Norton Rose Fulbright on behalf of
Adelaide Brighton Cement Limited

**Traffic and Transport Expert Evidence
Greater Geelong Planning Scheme
Amendment C395**

Norton Rose Fulbright on behalf of Adelaide
Brighton Cement Limited.
Our reference 16658PANEL001 D02 Geelong
Amendment C395

Figure 5.2: Western Growth Area Road Network Plan

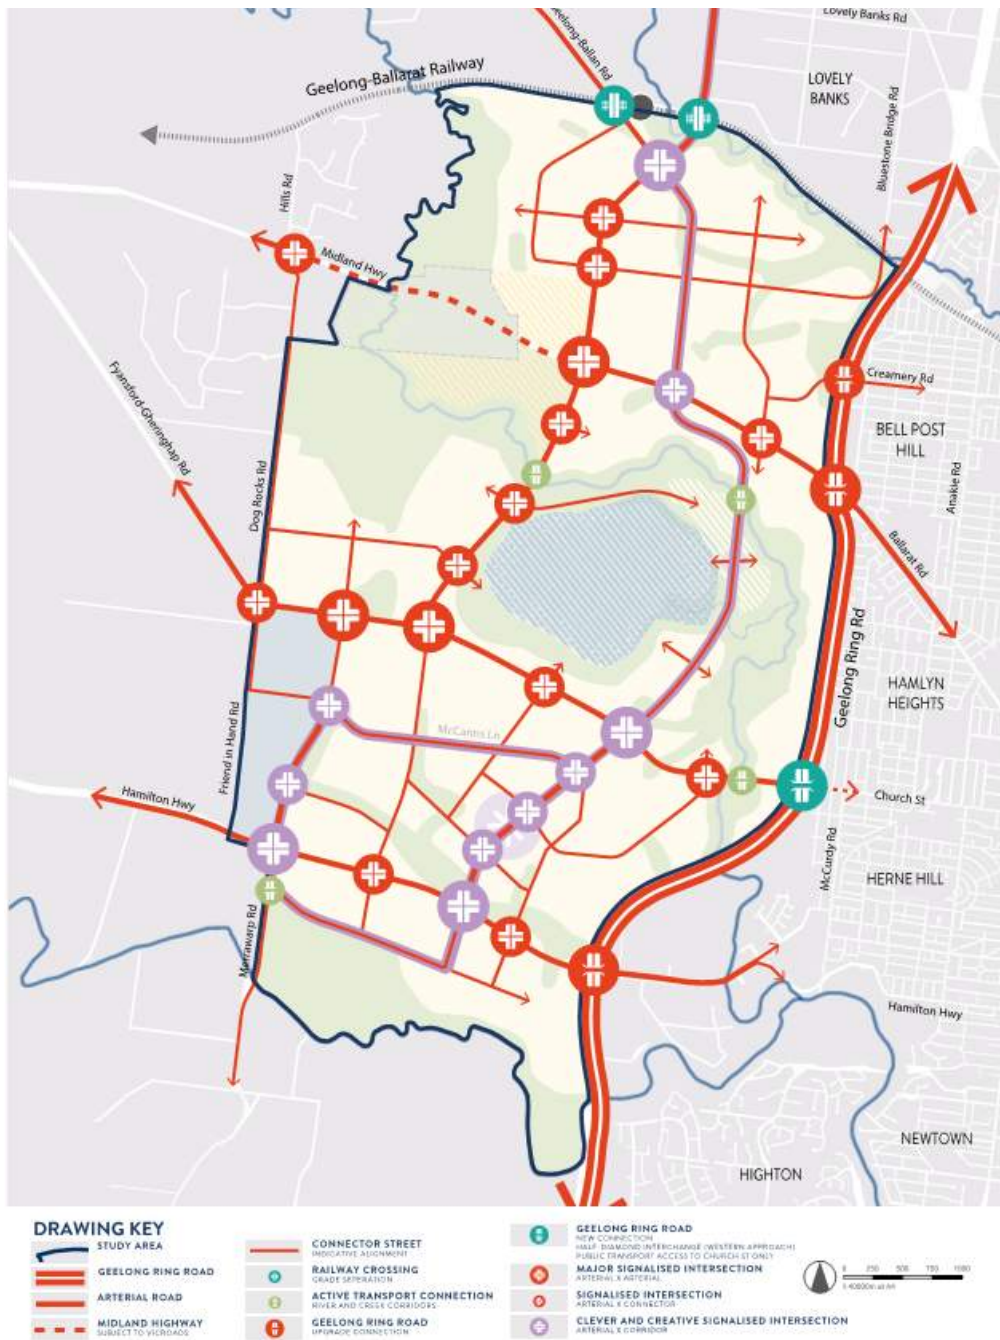
- 5.1.3 The Arterial Road is proposed to connect to Elcho Road to the north and use the existing Evans Road alignment between the two growth areas. After crossing the Geelong Ballarat railway line, the arterial then deviates from the Evans Road alignment to cross the existing Geelong-Ballan Road at right angles continuing at an angle to then straighten up and cross Midland Highway at Lynnburn Avenue.
- 5.1.4 The arterial continues south of Midland Highway, crossing Moorabool River then following the western bank of the proposed lake. The north south arterial then intersects with the east west arterial which proposes to connect Fyansford-Gherringhap Road to Church Street.
- 5.1.5 There is no direct arterial road connection between Midland Highway and Hamilton Highway. The continuation of the arterial road south of Fyansford-Gherringhap Road is shown as a connector road.

- 5.2.2 It is noted however that although the alignment continues to Hamilton Hwy the direct route south appears to be downgraded with priority transferred to the east west arterial, then south to Hamilton Hwy via the Clever and Creative Corridor.

- 5.2.3 I don't believe this is an appropriate location for the Western Arterial to end. Typically, you would expect the southern continuation to be an arterial connecting though to Hamilton Highway. As it is shown, vehicles will either use the Connector Road as a pseudo arterial or will divert to the east using the CCC link instead.

Figure 5.3: Alternative Arterial Road Alignments

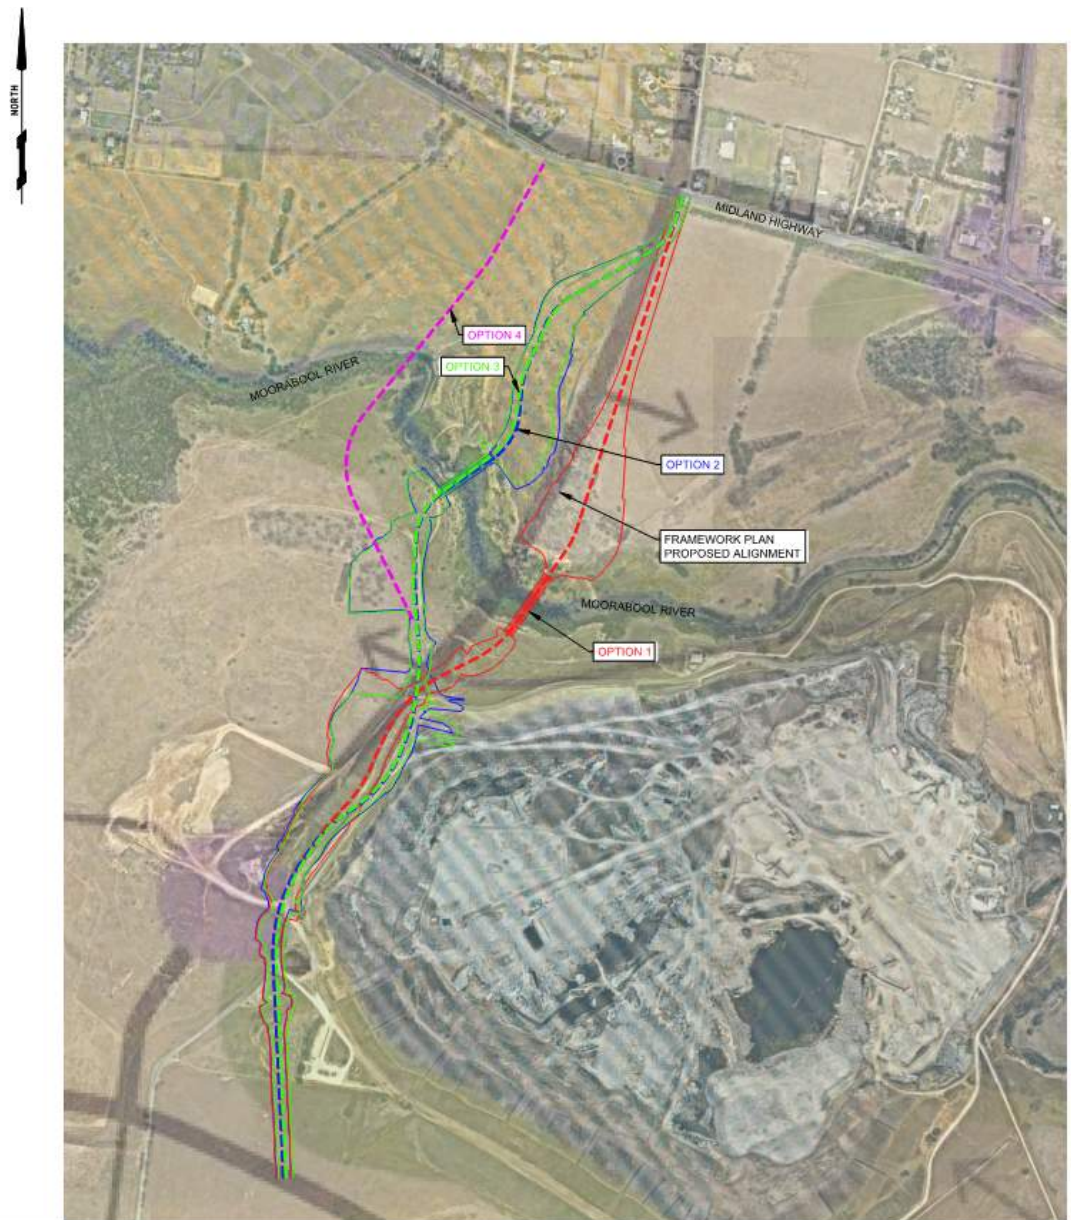
Option 1 aims to replicate the alignment shown in the Framework Plan, with the exception of the bridge crossing location which has been moved approximately 35m to the east, to reduce the bridge span required.

- 5.5.4 The dashed red lines either side of Option 1 indicate the extent of batter expected.

- 5.5.5 Option 2 uses the same intersection at Midland Highway opposite Lynnburn Road as proposed in the Framework Plan, the alignment then moves to the west, to cross Moorabool River approximately 300 metres west of Option 1.
- 5.5.6 Option 2 aims to take advantage of the side of the hill to reduce the overall longitudinal grades along the road alignment.

- 5.5.7 Option 3 uses the same alignment and river crossing location as Option 2, but has a split carriageway in some locations to better reflect the topography.
- 5.5.8 As cross sections and a longitudinal section have not been prepared the difference between Option 2 and 3 is not discernible based on the information provided.

- 5.5.9 Option 4 uses an alternative access location to Midland Highway, approximately 300m to the west of Lynnburn Road. The resulting Moorabool River crossing location is approximately 600m upstream from Option 1.
- 5.5.10 After crossing Moorabool River, Option 4 curves to the south east to join up with the preceding 3 options adjacent to the lake.
- 5.5.11 Option 4 was not explored in detail by Cardno TGM as they determined that the bridge span, due to Moorabool River flood plain, would be approximately twice the length of the other options, which would significantly increase the cost of construction for Option 4.

- 5.5.12 All four options deviate to the east of the proposed road alignment at the southern end of the proposed lake. The Cardno TGM letter dated 23/7/2019, states that all four options have adopted the deviation to the east at the southern end due to a 15m high embankment that would require extensive earthworks to achieve appropriate grades.
- 5.5.13 It is noted that in the framework plan an activity centre appears to be located on top of the hill referenced by Cardno TGM.

Figure 5.4: View of escarpment where current arterial road would cross Moorabool River

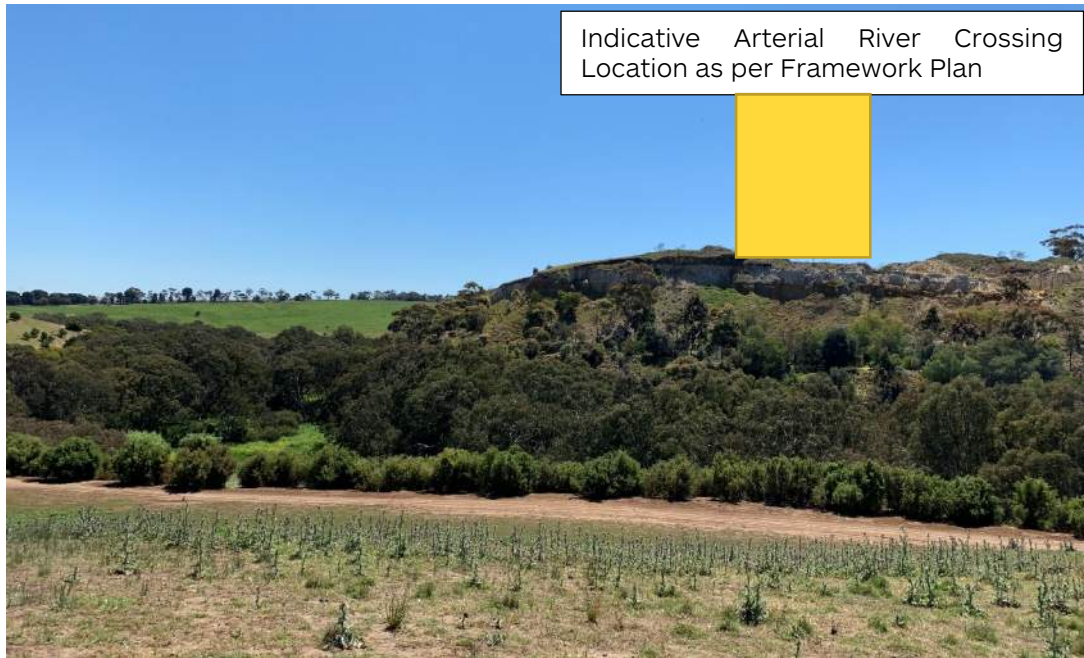
- 5.6.7 As shown in the preceding photo, the proposed river crossing location shown in the Framework Plan crosses at one of the highest points of the escarpment along the northern side of the Moorabool River north of the future lake.
- 5.6.8 I was advised by Adelaide Brighton that the escarpment shown in the photo needed remediation works due to historical mining practices along the creek.

Figure 5.7: Alternative Western Arterial Road Alignments Prepared by Cardno TGM

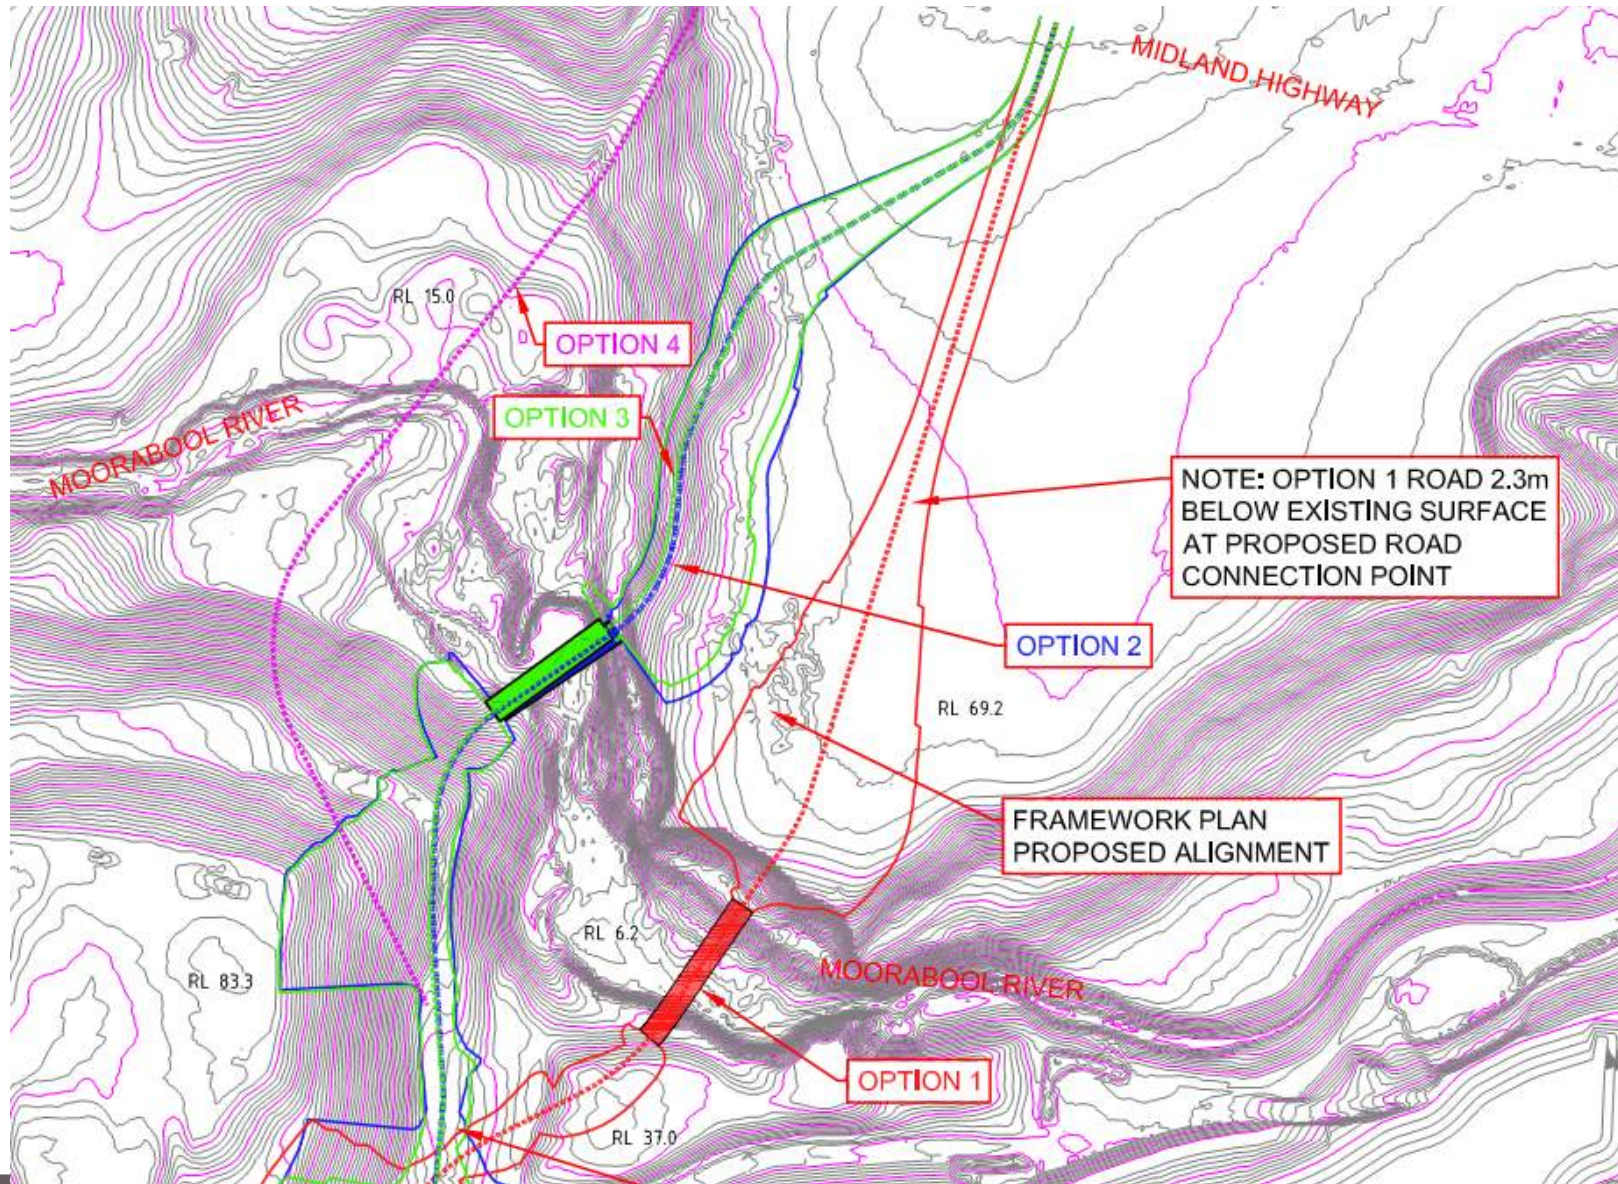
- 5.8.2 As shown in Figure 5.7, the lines indicating batter are generally only required on the eastern side of Option 2/3, compared to the considerable width required for Option 1. This is due to Option 2/3 being cut into the side of the hill rather than in trench through the hillside as per Option 1.

- 5.8.3 All options considered demonstrate that more land will be required than a typical 34m arterial to accommodate batters, retaining walls etc.
- 5.8.4 The preliminary work undertaken by Cardno TGM suggests that the arterial road and associated bridge crossing through the Batesford South PSP area will cost substantially more than a typical arterial road.

- 5.9.1 Based on the preceding review, I believe there is merit in relocating the Arterial Road further to the west for the following reasons:
- Option 2/3 as provided appear to respond more sympathetically to the topography, potentially requiring less earthworks, retaining walls and batters.
 - Moving the road to the west would potentially negate the need for a significant trench through developable land.

Figure 6.3: Clever Creative Corridor through the Western Growth Area

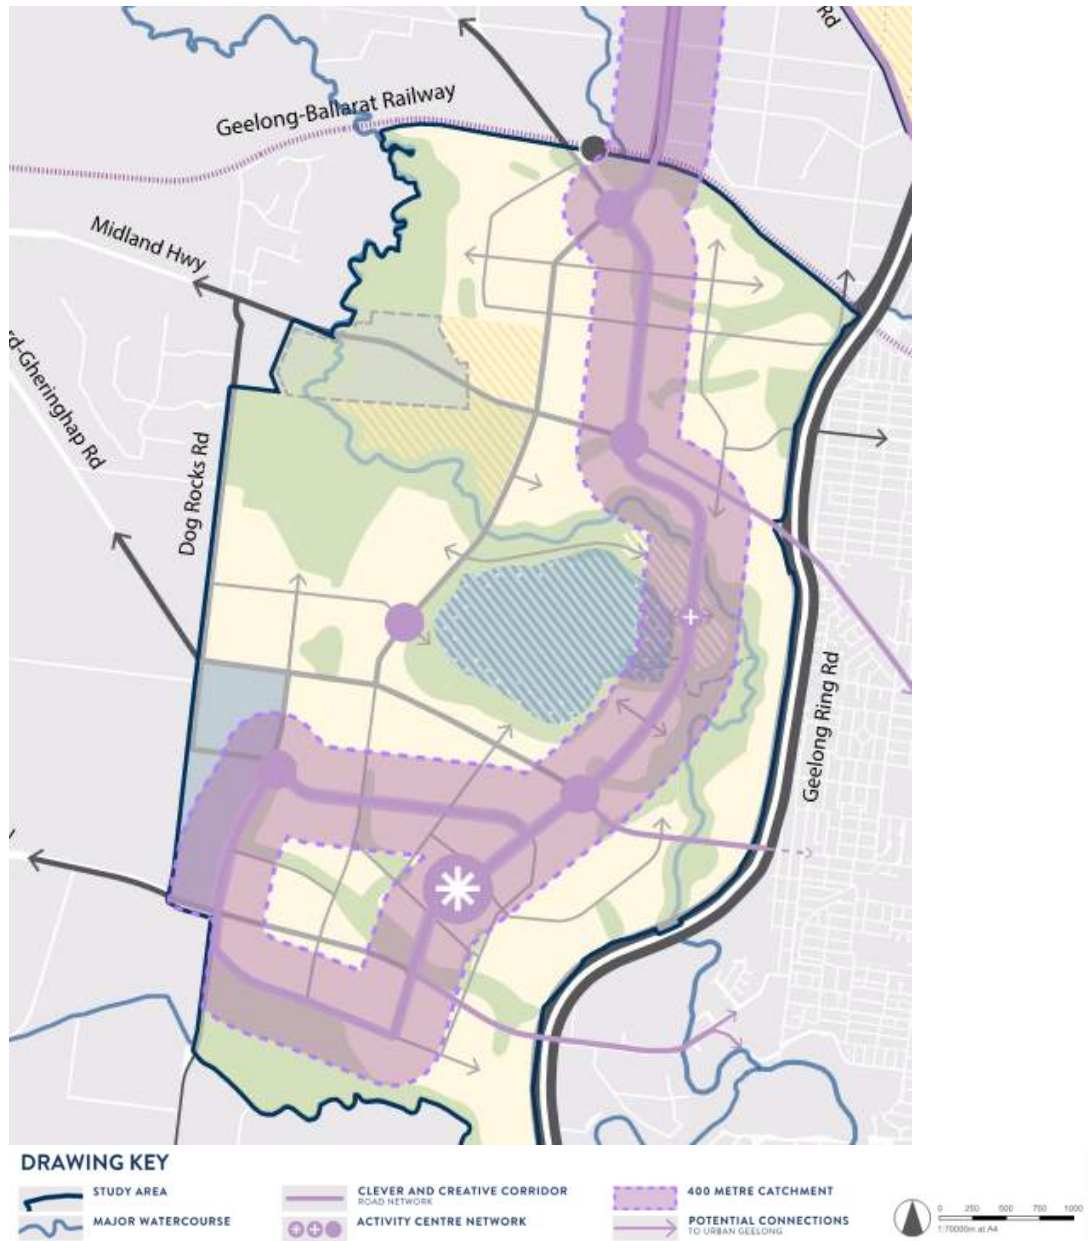
- 6.2.2 Although only a 400m catchment area is shown on the preceding plan the transport corridor will also provide convenient services for residents up to a km from the stops noting that this would be a 10-12 min walk.
